Alternators with Field Isolation

Alternators with Field Isolation 2

JAS have rationalised our Heavy Duty Prestolite Commercial Alternator Range to make the following change. All Prestolite Alternators, **ANP2289GQ**, **ANP2287GQ** and **APN2310GQ** are now Field Isolating type units.

E61-75903

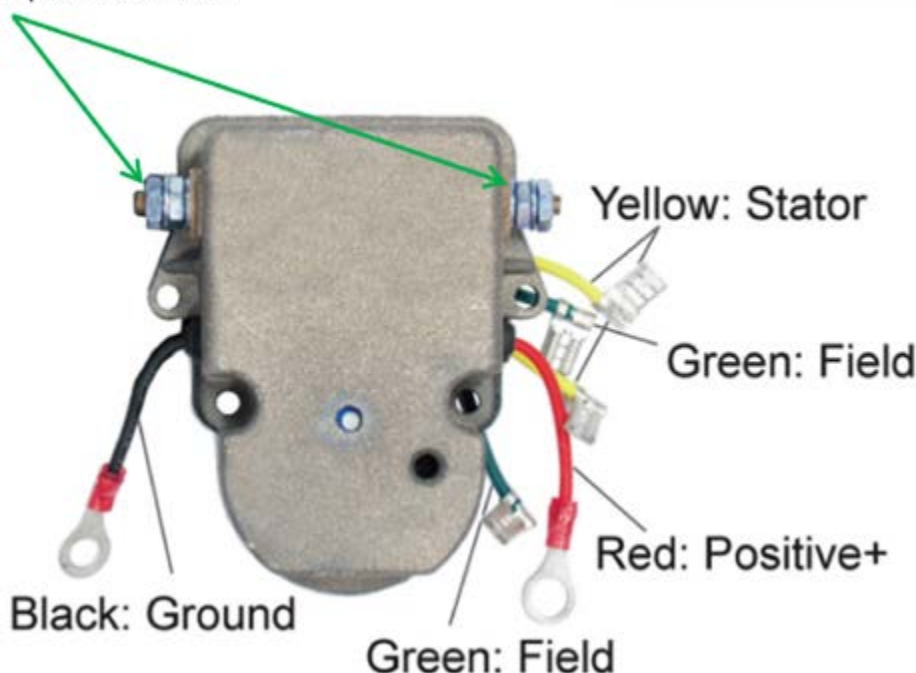
In the picture below you will notice the 2 studs that come out of the Prestolite type Regulator, the Alternator field circuit must be completed through these 2 terminals for the Alternator to operate.

These Alternators all have field Isolation type regulators fitted, (see Tech Tip 71 for an explanation of field Isolation). All Alternators are supplied with the Field Isolation circuit bypassed and to be used as field isolated this bypass wire simply needs to be removed and the field isolation circuit completed through an external isolating circuit. See images attached.
